1955 PITTWATER ROAD, BAYVIEW

S4.55 AMENDED PLANS

DRAWING LIST

COMPARISON PLANS

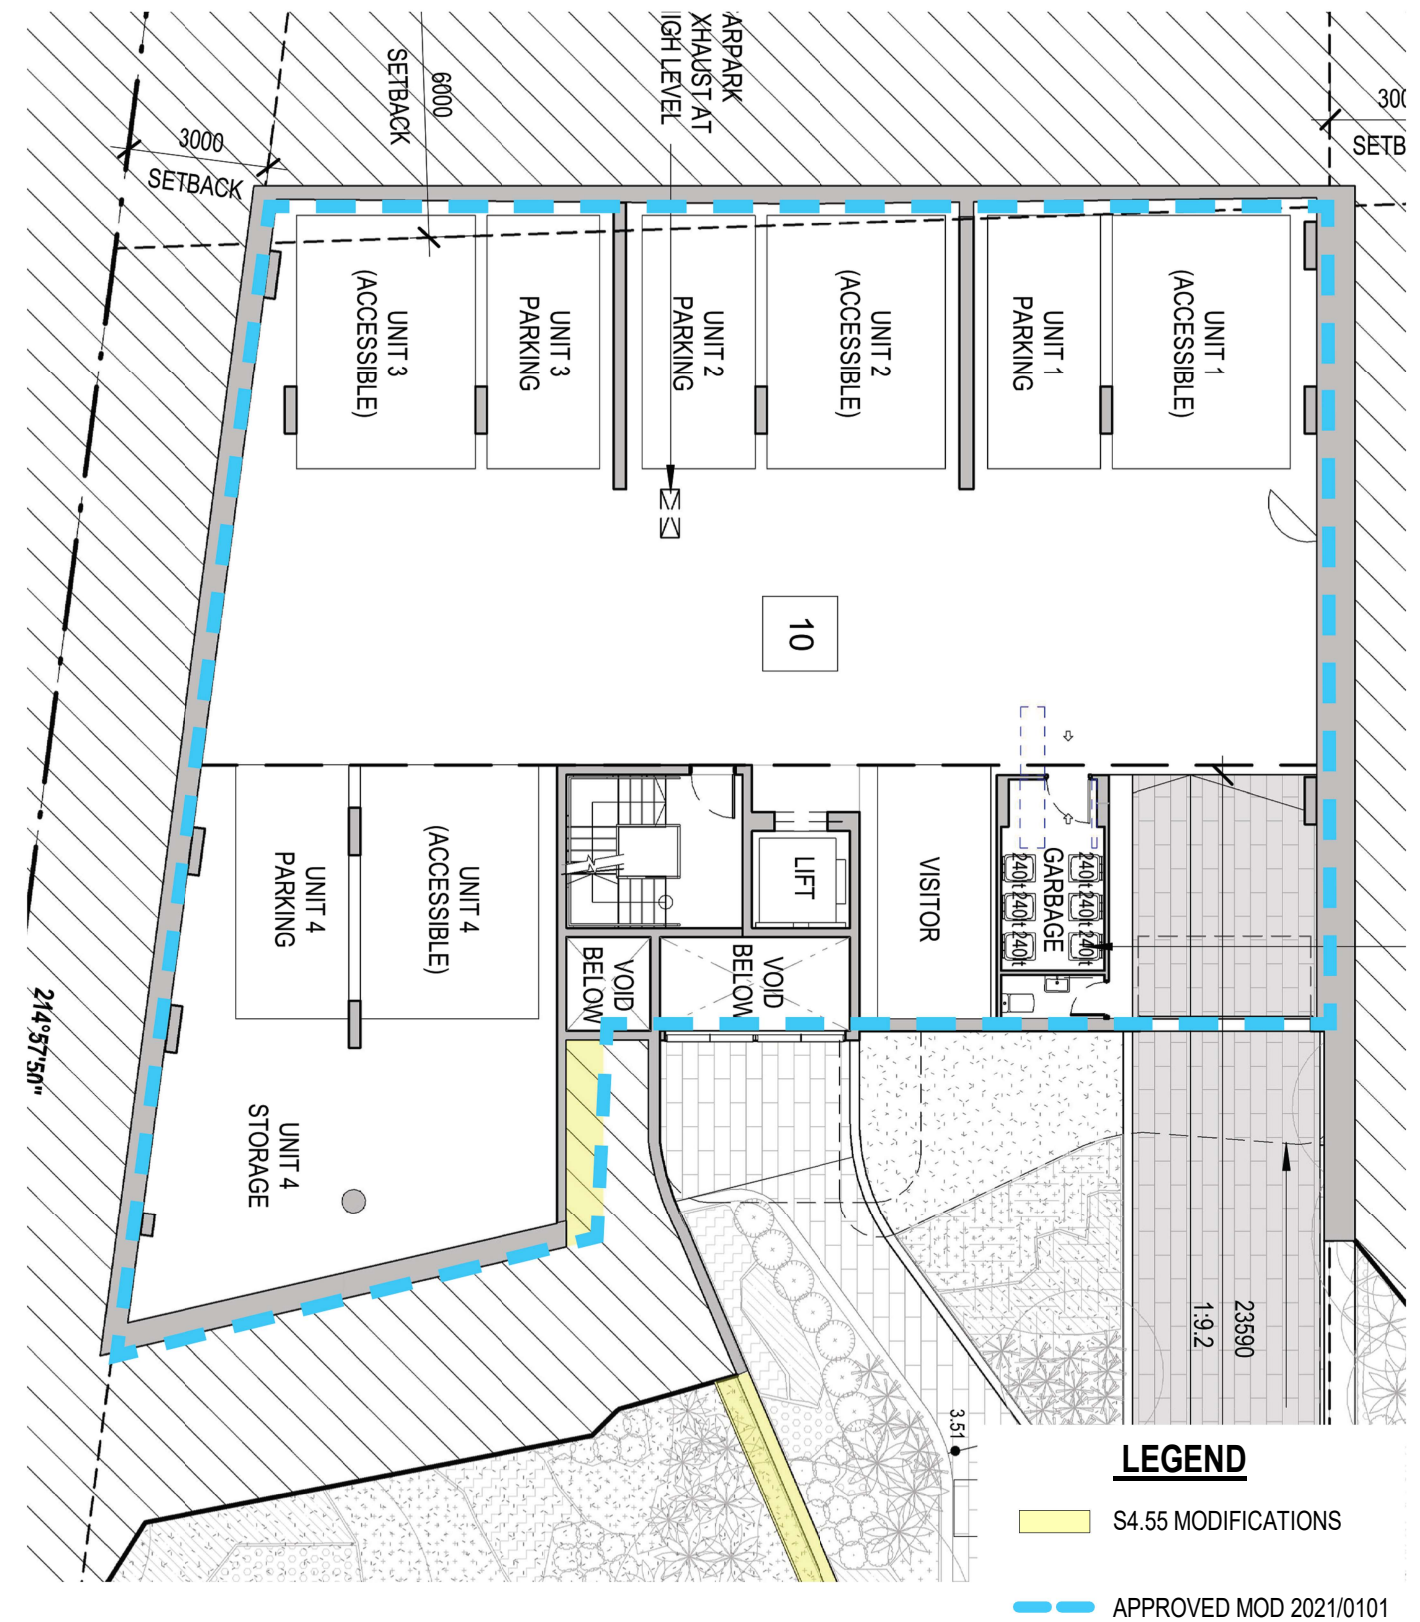
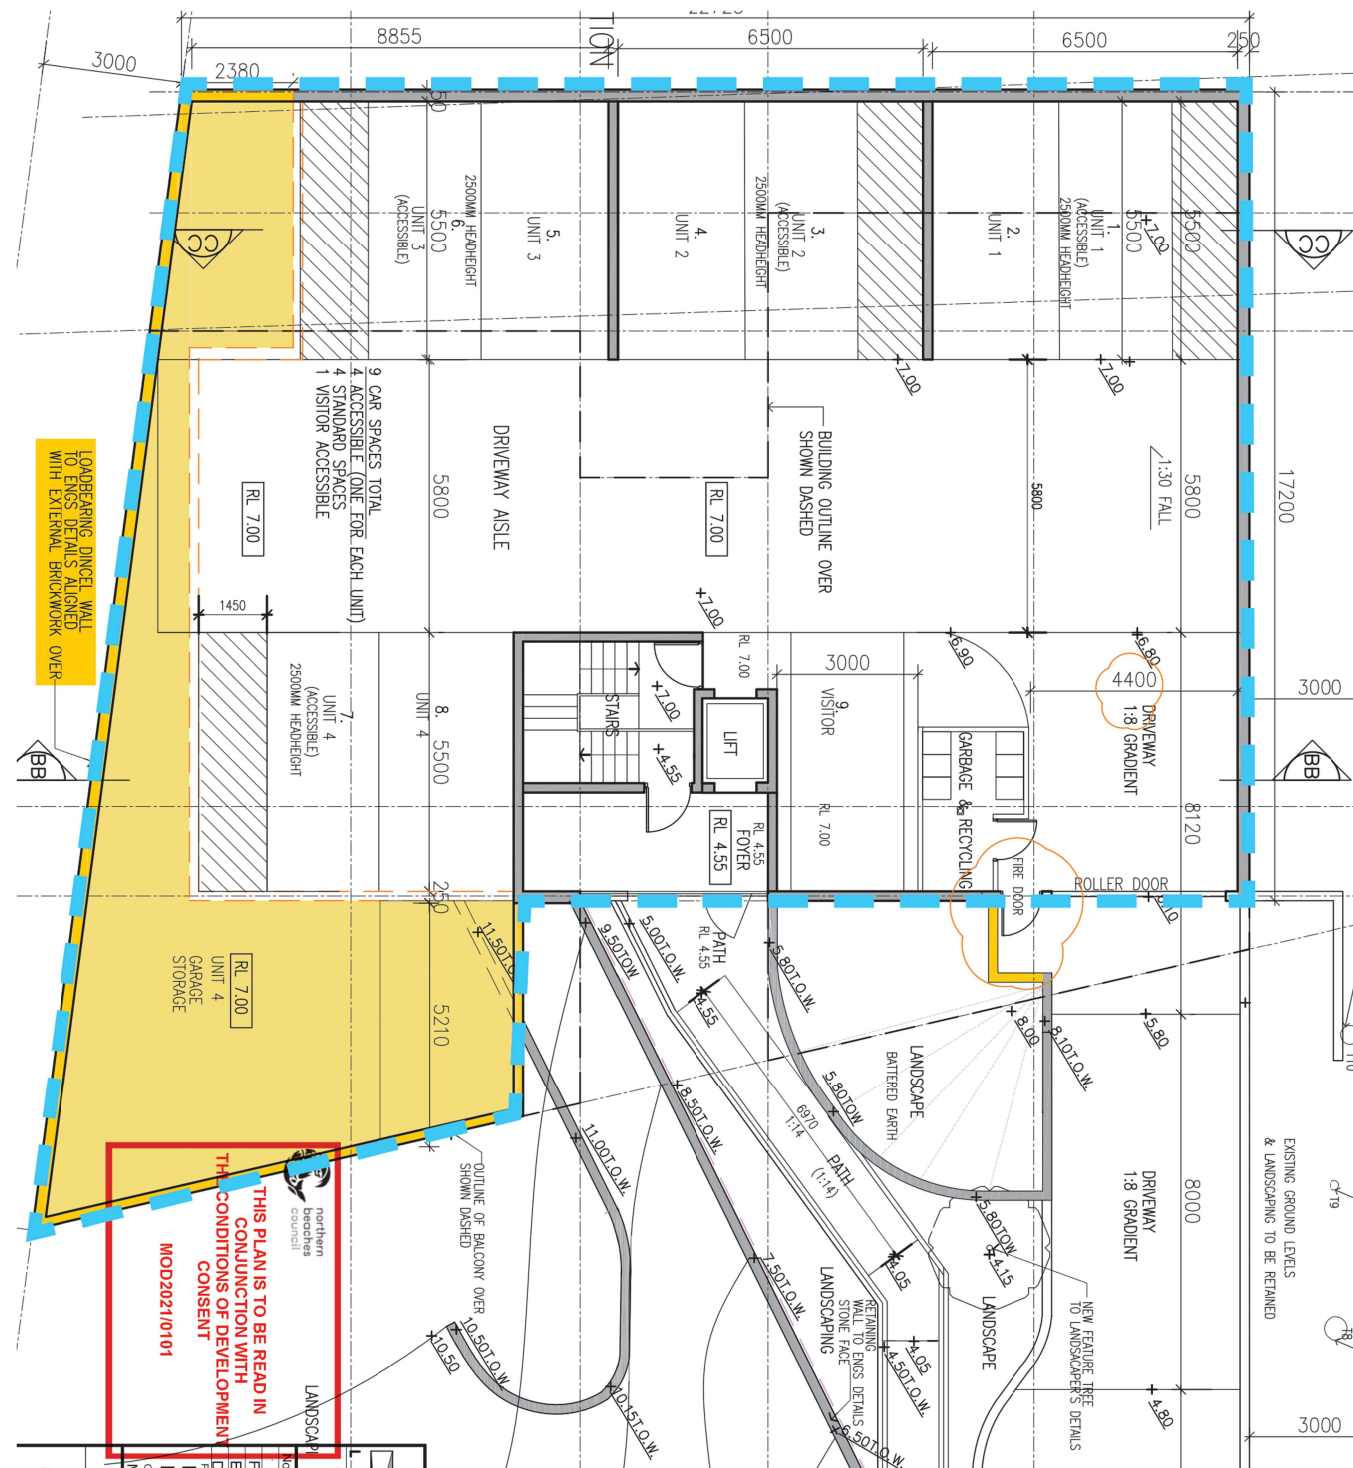
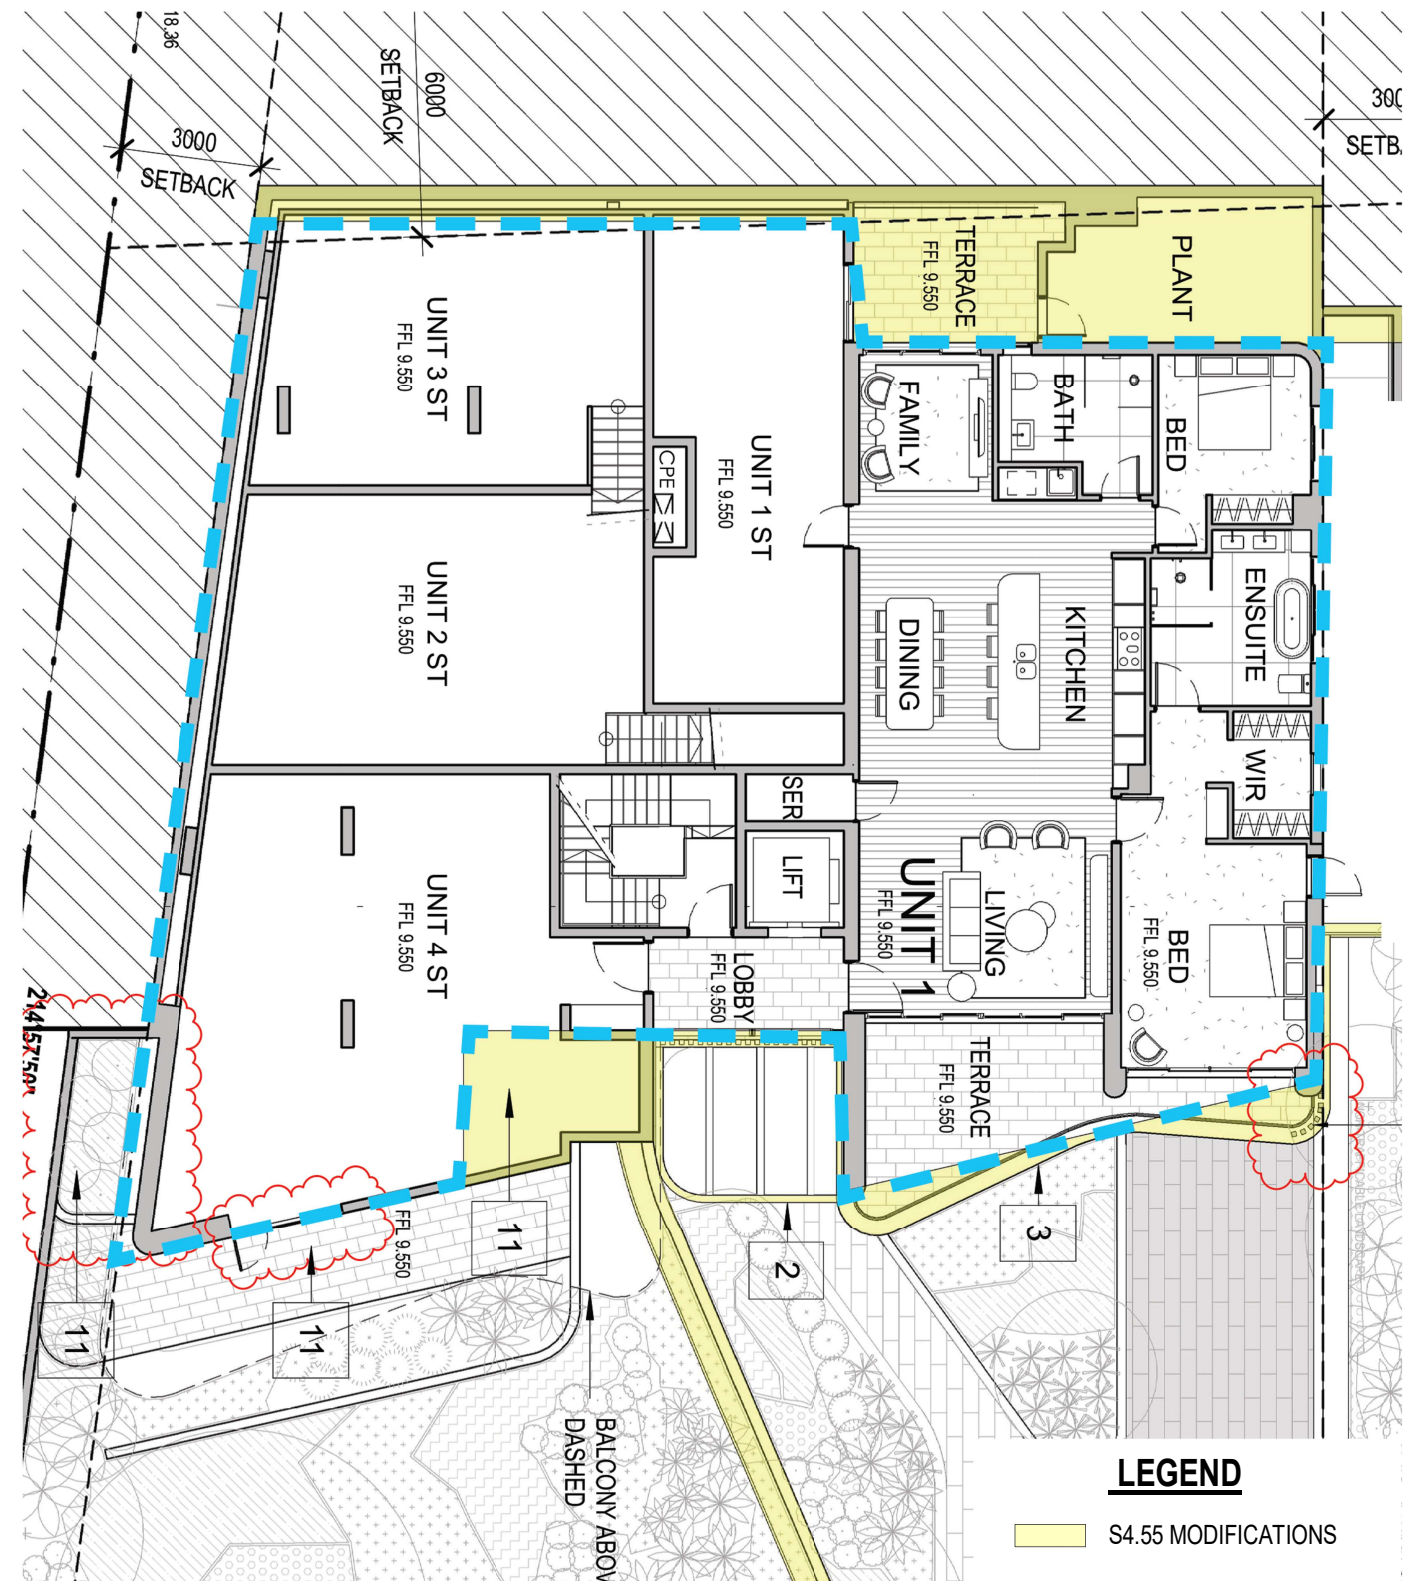
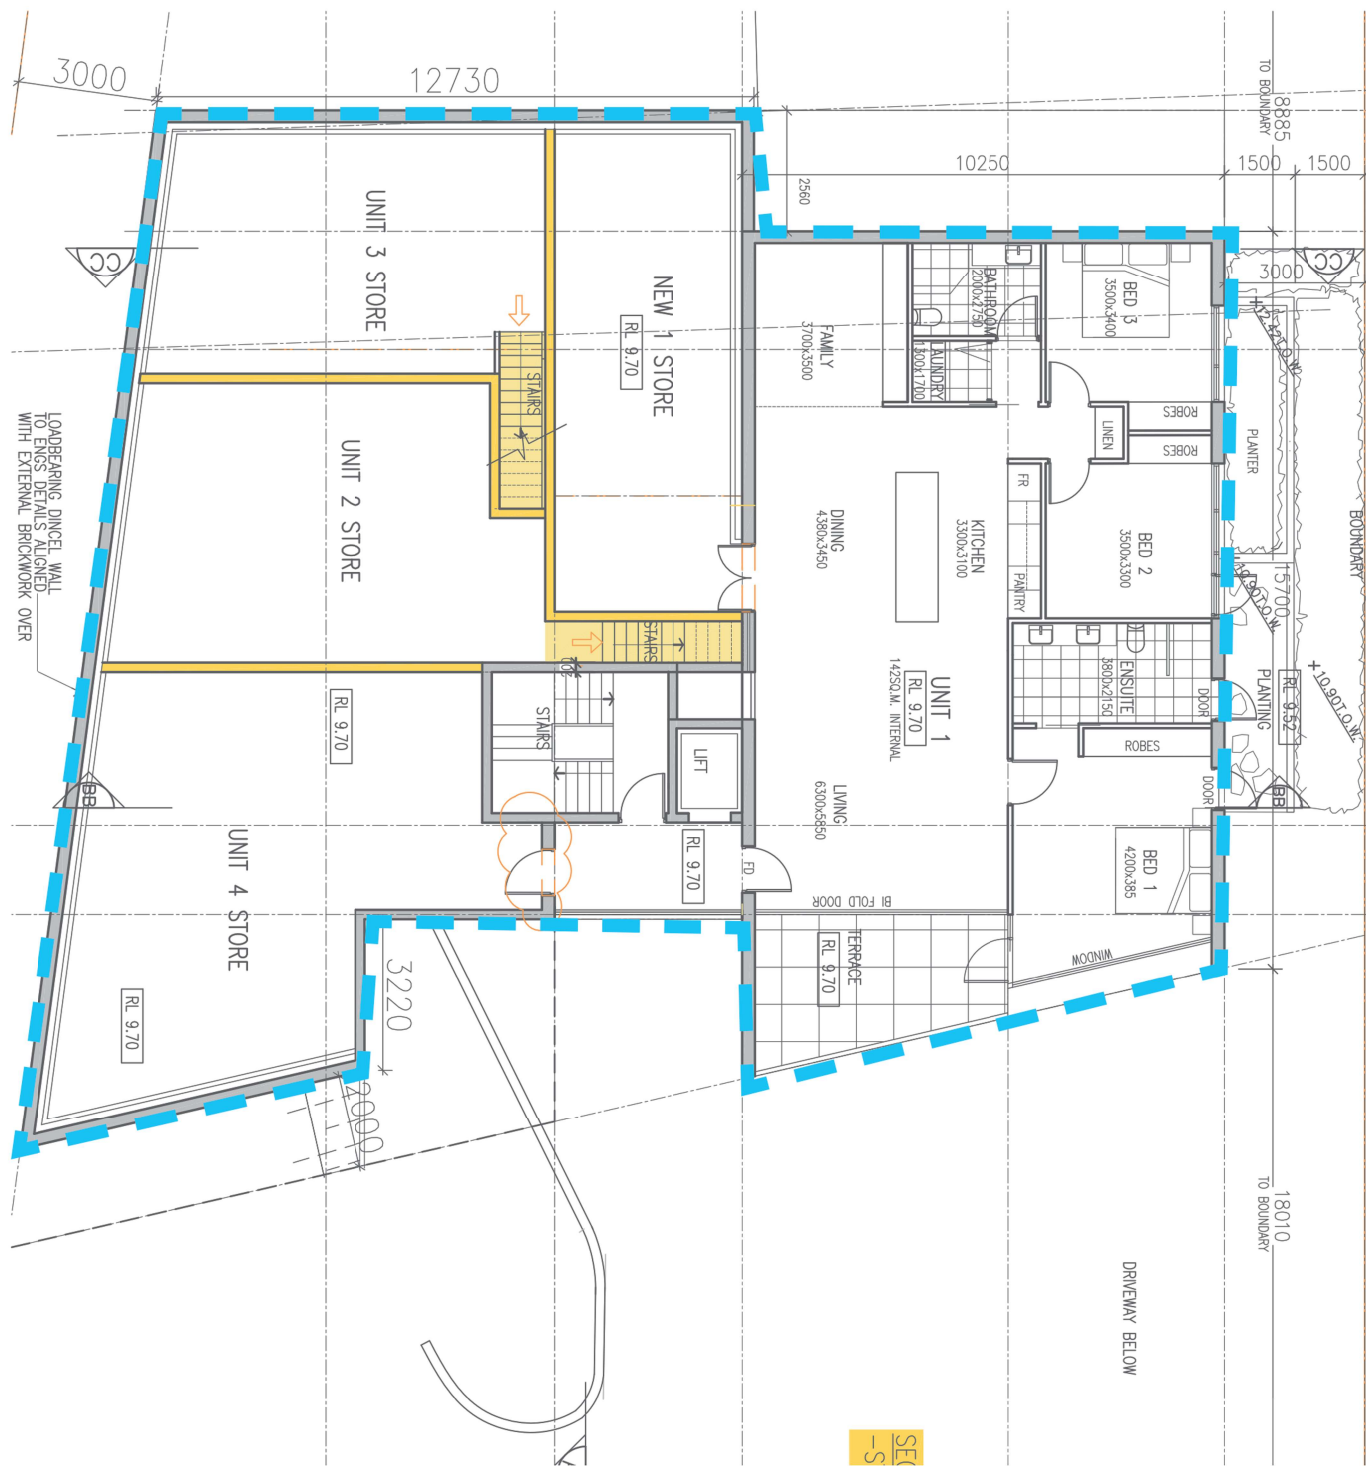
S4.55 MODIFICATIONS
